BNPM/NCB/RO SYSTEM/275/2019-20	BANK NOTE PAPER MILL PRIVATE LIMITED	
	CORRIGENDUM NO. 2

**CORRIGENDUM No. 2, DATED 21.08.2019**

**BNPM/NCB/RO SYSTEM/275/2019-20 Dated 06.07.2019**

**TENDER FOR SUPPLY, ERECTION, TESTING, COMMISSIONING, PERFORMANCE TESTING OF 65m<sup>3</sup>/HR SYSTEM AT BNPM PLANT, MYSURU**

DO NOT SCALE		
 <b>BANK NOTE PAPER MILL INDIA PRIVATE LIMITED</b> Mysore - 570003		
SCALE: -SCALE		DATE: 20/08/2019
OFFICE-DWG:		
DRN:	TITLE: LAYOUT DRAWING OF UF+RO	
CHD:	DWG NO: BNPM\URR\ETP\UF&RO layout - 1	ISSUE

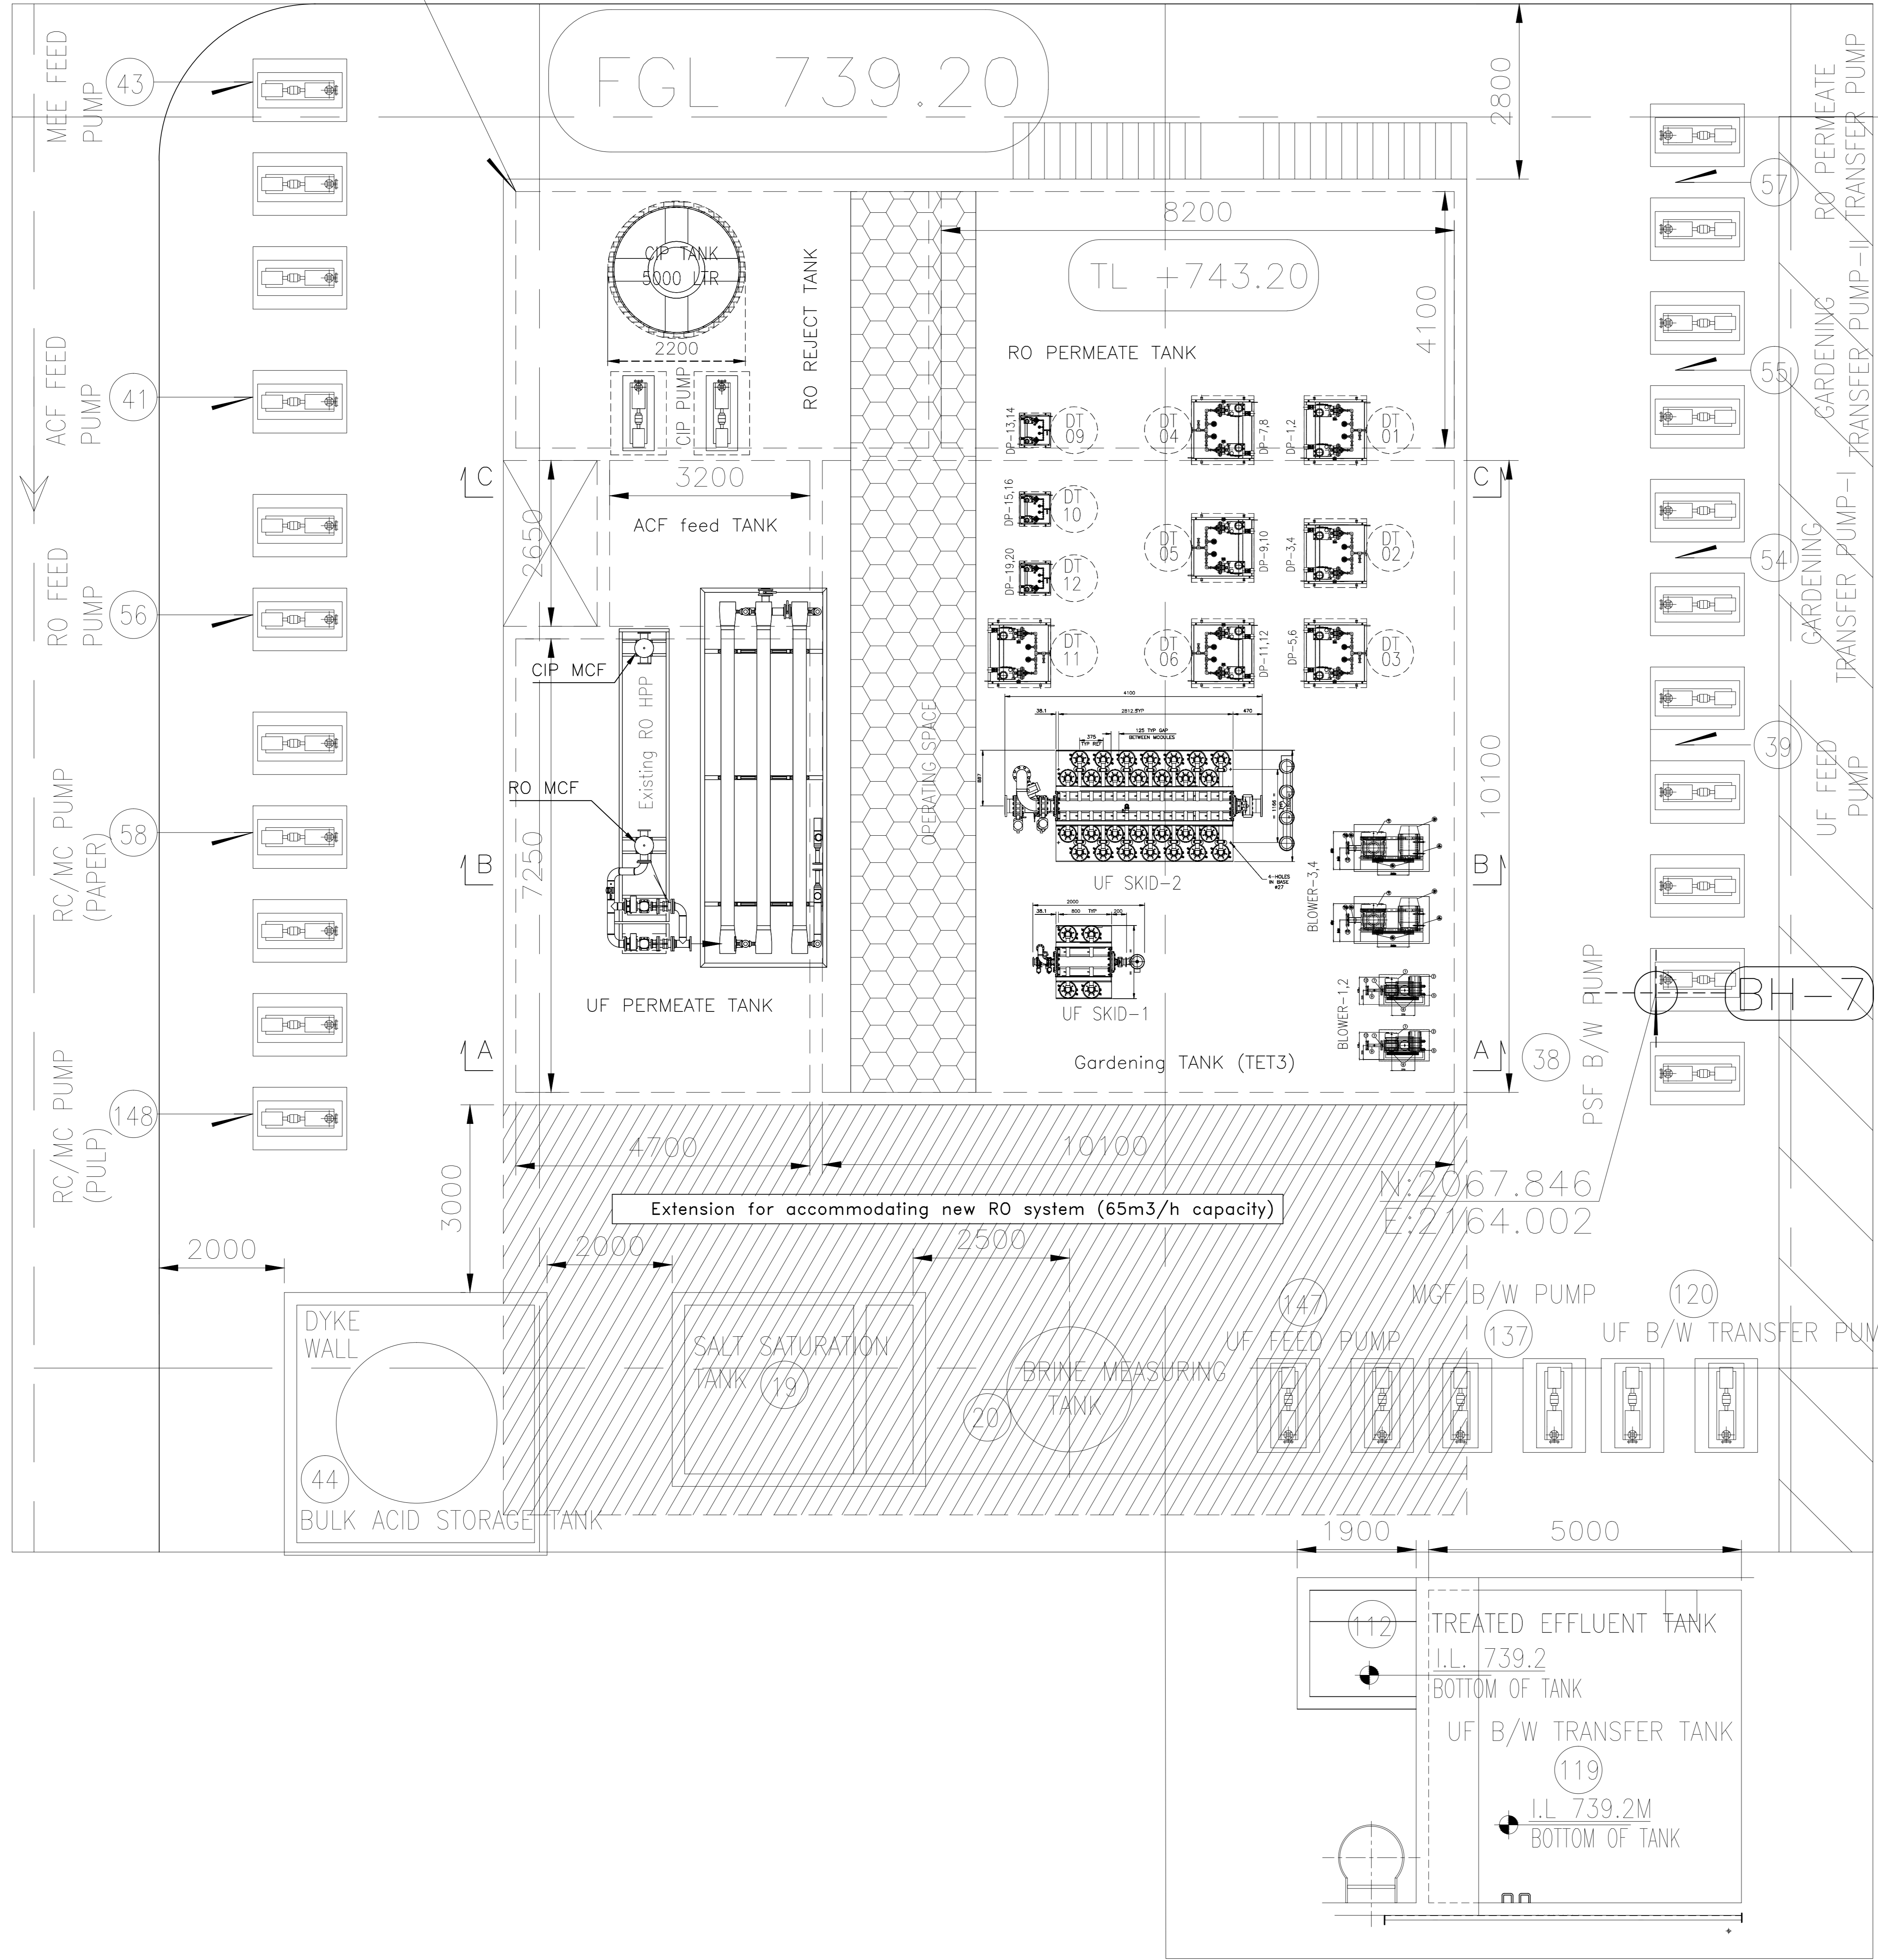
3.	Section VII-C. General Terms & Conditions: Sl No 17 under Clause C - General terms and Conditions	Bidder has to submit the system plan / layout with clear area requirement of the new RO plant. The bidder is to visit the site before quoting to verify the space availability.	Existing plant layout may be provided to understand the accommodation of new RO plant.	Attached plant layout may be referred to.

01. The Source of water for the 65m3/h RO system is UF permeate water.
02. The feed water should be pumped from the UF permeate tank to the new RO system.

03. Permeate from the new system should be routed to the existing RO permeate tank
04. The reject from the new system should be routed to the existing RO reject tank.

05. By-pass arrangement to be provided for diverting the RO reject after 3rd stage to gardening tank if TDS less than 2000 ppm.
06. Design and drawing of civil structure to be submitted by the bidder, area requirement to be analyzed by the bidder after visiting site.

07. The routing of pipe line from the UF permeate tank to the RO system and the permeate and concentrate pipe lines to the permeate and reject tanks (inclusive of puddle flanges) will be in the scope of party.

08. The shown extension (hatched area) is just for representational purpose, the party has to check the space requirement and design the civil structure accordingly.
